EVIDENCE IN THE MATTER OF PC 75

Evidence of Gabi Wolfer, Senior Urban Designer/Town Planner, Selwyn District Council

PROPOSED CHANGES TO ODP

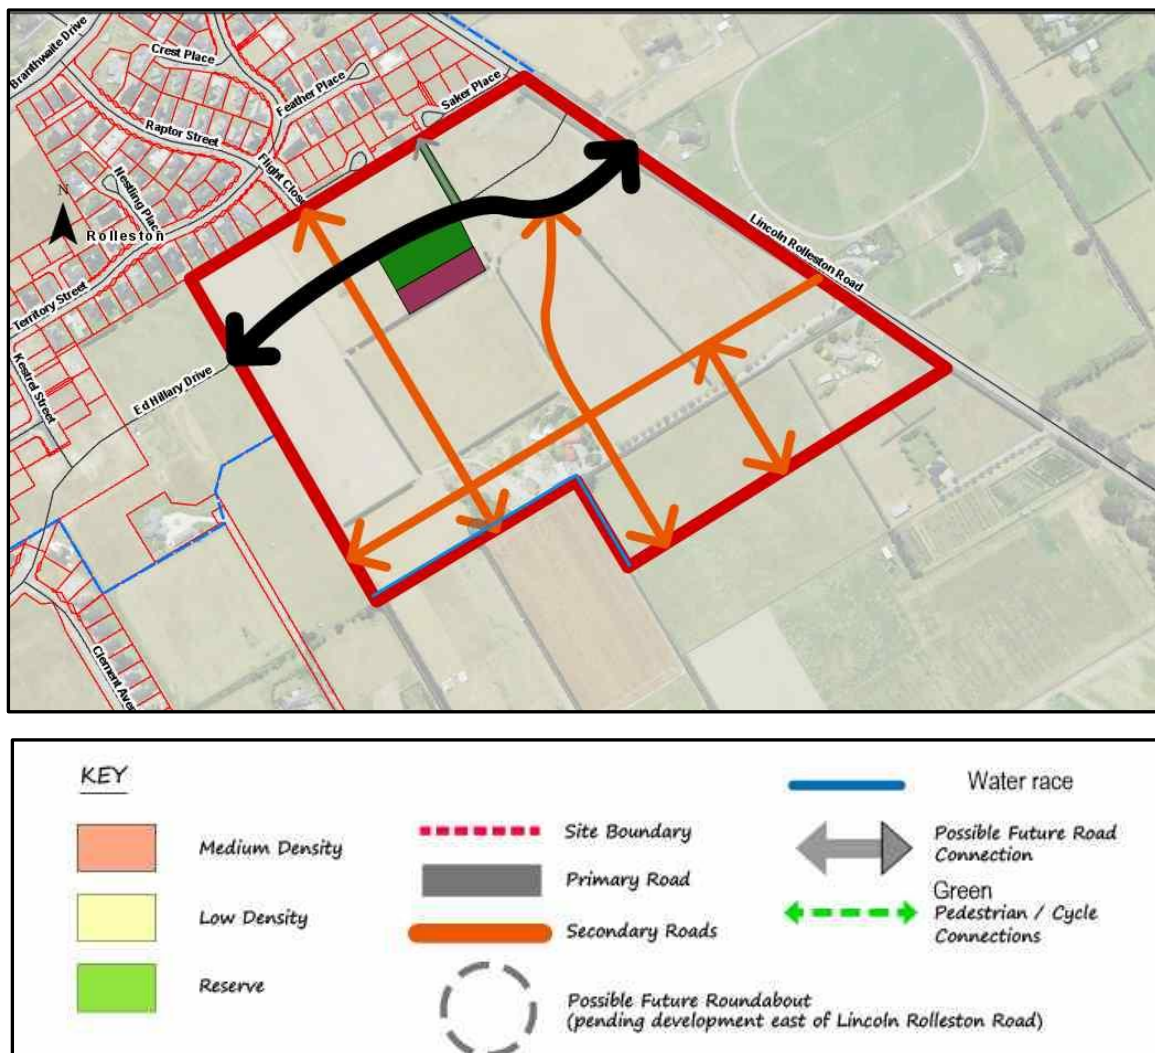
- 11.7. I recommend that the proposed secondary north- south connection is amended to align with the adjoining neighbourhoods to the north (Falcon's Landing) and future development to the south and west (Acland Park via PC78).
- 11.8. I recommend that the secondary east-west connection on the ODP is realigned to ensure consistency with Figure 7 of Councils' Transport experts' evidence.
- 11.9. I recommend the pedestrian and cycle links on the OPP to be amended as per point 82.
- 11.10. I recommend that the ODP legend to show a 'double arrow' referring to a future link.

- 11.11. I recommend that the ODP text indicates that individual sections have direct access onto Lincoln-Rolleston Road and to include a note labelled 'interface treatment' on the ODP plan.

- 13.7. Shift the proposed secondary north- south connection to align with adjoining neighbourhoods to the North and future development to the South.
- 13.8. Amend Secondary East-West connection on the ODP in line with figure 7 of the Council's transport engineer's hearing report.
- 13.9. Incorporate east-west and north-south pedestrian and cycle links at the interface with PC78 into the overall roading network. Retain north-south off-road connection to Falcon's Landing on the ODP.
- 13.10. Show line along Lincoln Rolleston Road labelled 'interface treatment'
- 13.11. Amend the ODP's key to show a 'double arrow' when referring to a future link.

- 13.12. Show water race alignment
